FAIRFAX COUNTY

May 5, 1998

Re: Interpretation for PCA C-448-16, FDP C-448-31 and SP 97-D-051; Green Property, Shift
in Restaurant Location and Redesign of the Parking Lot

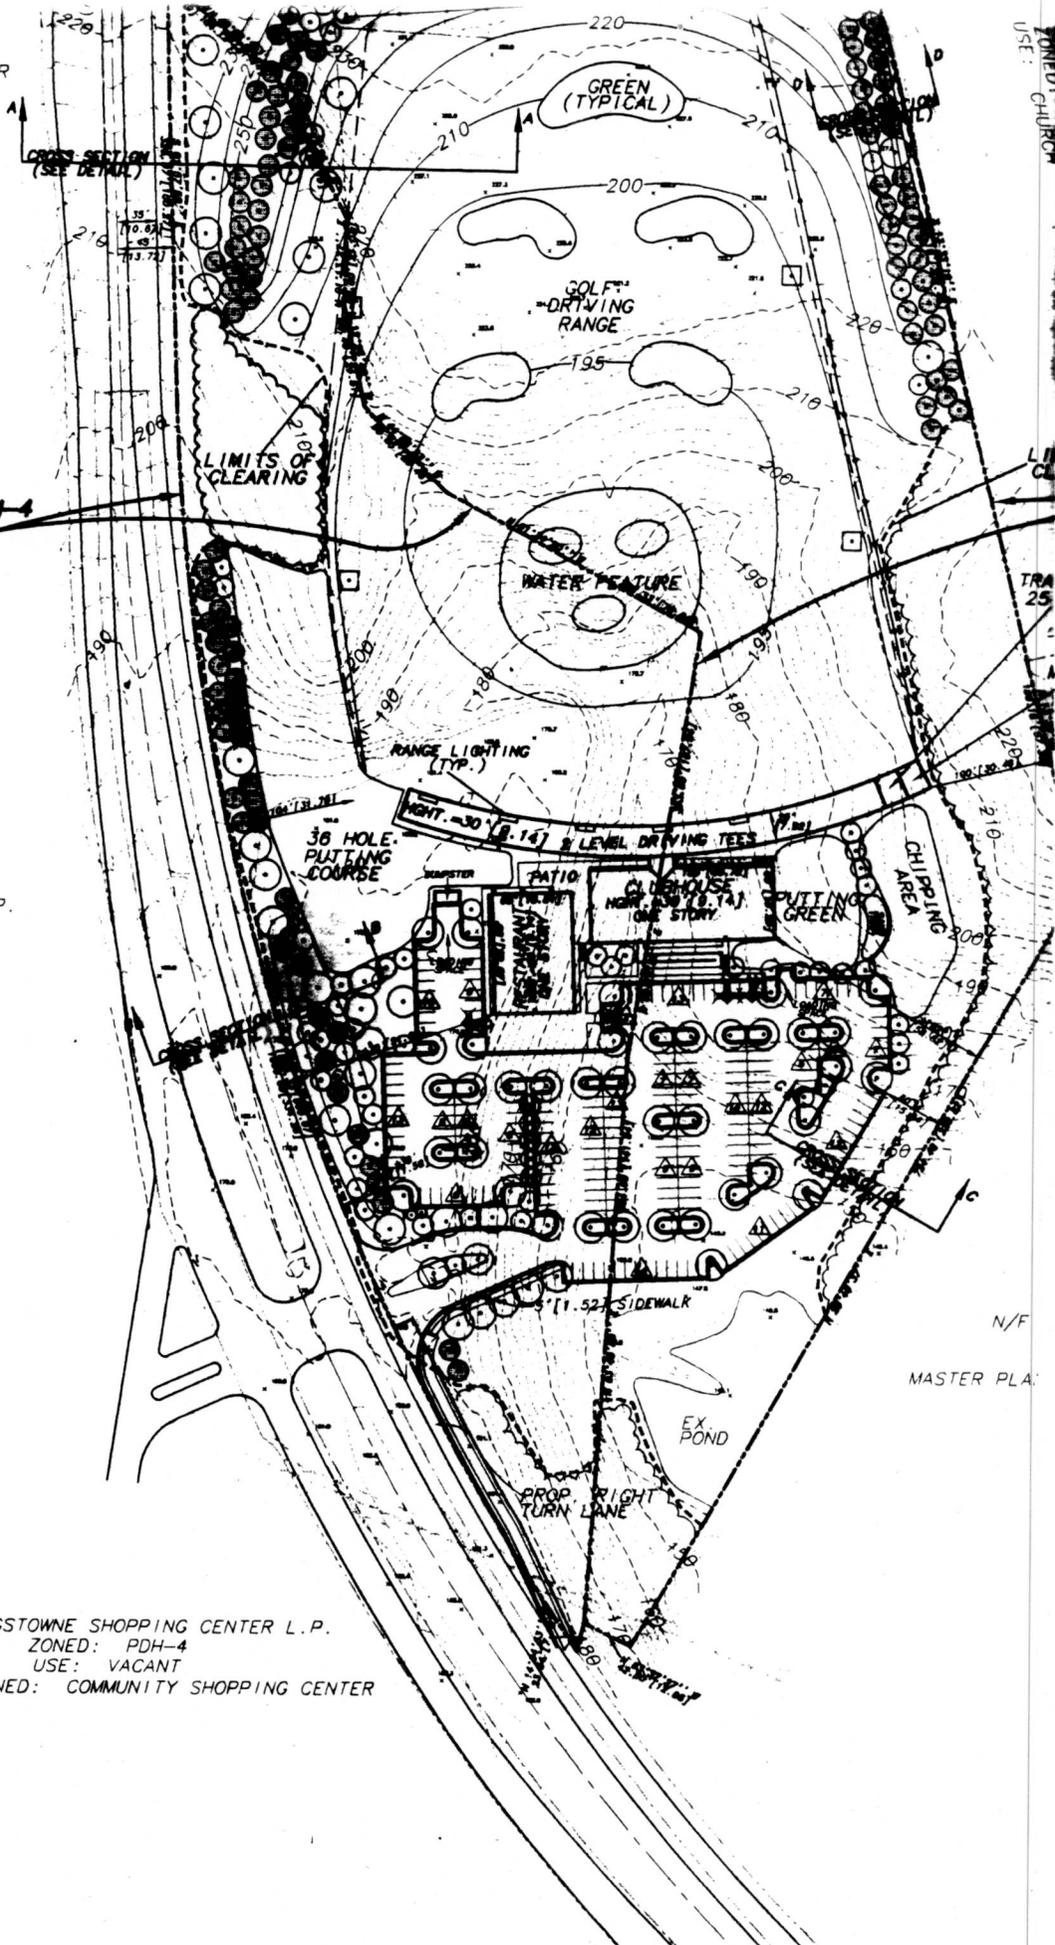
- Removing the twelve (12) parking spaces located immediately north of where the entrance narrows at the beginning of the parking lot. (The affected area is circled on the portion of the interpretation plan attached to this letter).
- The five (5) foot sidewalk shown adjacent to those space located in the center of a landscaped area incorporating the displaced parking, with ornamental and deciduous trees lining the sidewalk.
- A sidewalk shall be provided on the north side of the entrance road from the trail along S. Van Dorn Street.

It is my determination that the proposed relocation of the restaurant building would be in substantial conformance with the proffered CDPA/FDP/SP Plat provided that landscaping between the parking lot and S. Van Dorn Street complies with the planting density required for Transitional Yard 3 and a canopy connecting the two buildings is installed.

It is my further determination that the revised parking lot layout would be in substantial conformance the proffered CDPA/FDP/SP Plat provided that the number of parking spaces is reduced to a total of 226 as depicted on the proffered plan and the pedestrian pathway from S. Van Dorn Street to the clubhouse and restaurant is enhanced as follows:
